**CONESTOGA-ROVERS
& ASSOCIATES**

QUANTITY	DESCRIPTION
3	Remediation Investigation/Feasibility Study
	Land West of Building B
	Caterpillar Inc. - Mapleton, Illinois

QUANTITY	DESCRIPTION
1	CD containing RCRA Investigation/Feasibility Study - Swale Area
	Caterpillar Inc.
	Mapleton, Illinois

COST PROJECTION
ALTERNATIVE 4 - PARTIAL EXCAVATION/DISPOSAL AND CAPPING/VEGETATIVE COVER
SWALE AREA
CATERPILLAR INC.
MAPLETON, ILLINOIS

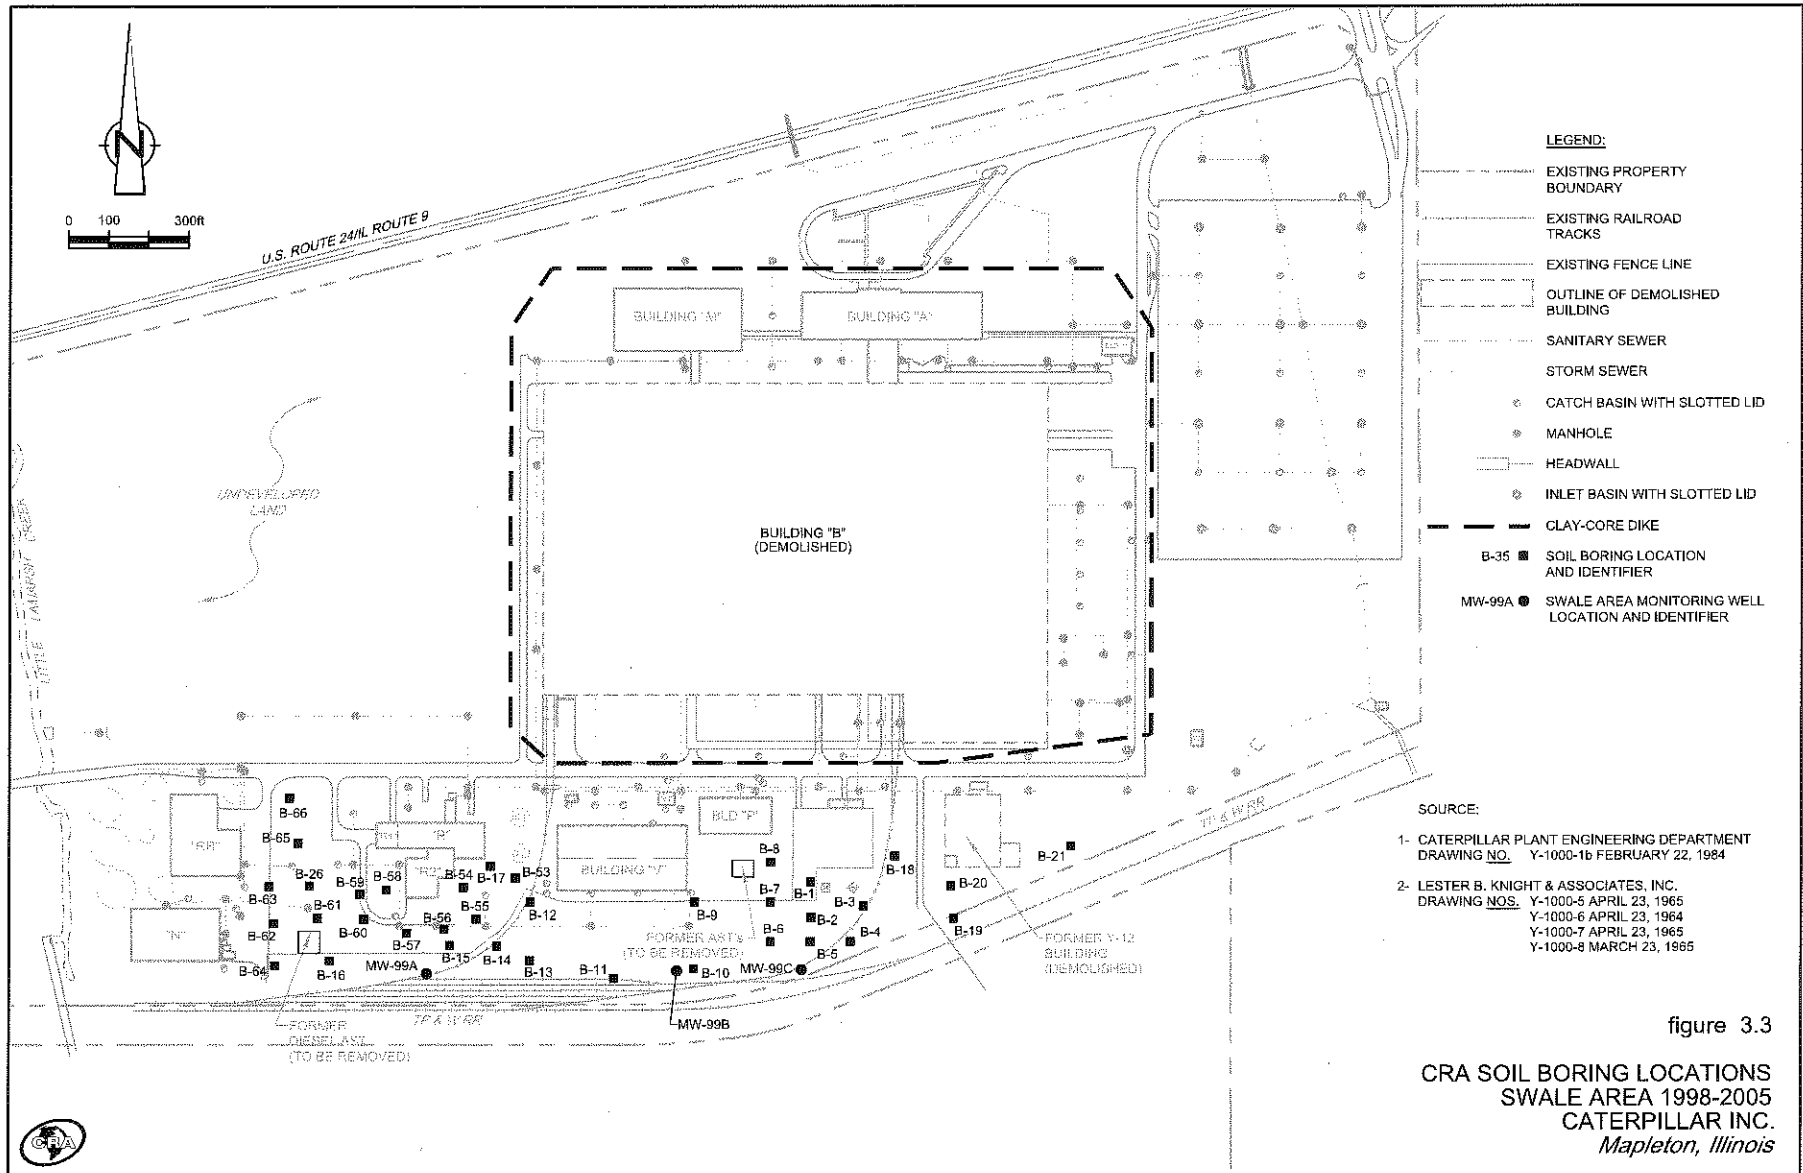
2. The analytical data indicates that there are PCBs greater than 50 ppm at the site. The work plan indicates that there are no PCBs greater than 25 ppm on the site and that there is no remedial action necessary to meet the low occupancy standards of the PCB regulations. The greatest concentration (1200 ppm) is found in analytical sample S-030205-JH-040. This sample is in the group referenced in question one. There is one reference to this sample on page 14 in the last bullet item under Section 4.2. It is identified as B-56 which is not shown on Figure 4.1.

3. The PCB units on Figure 4.1 are identified at ug/kg when the units are mg/kg.
4. Has there been any previous removal of PCB contaminated material at the site? The RCRA drum area has elevated levels of PCBs and it seems that this might have been remediated. If so, were there any confirmation samples taken and what are the results?
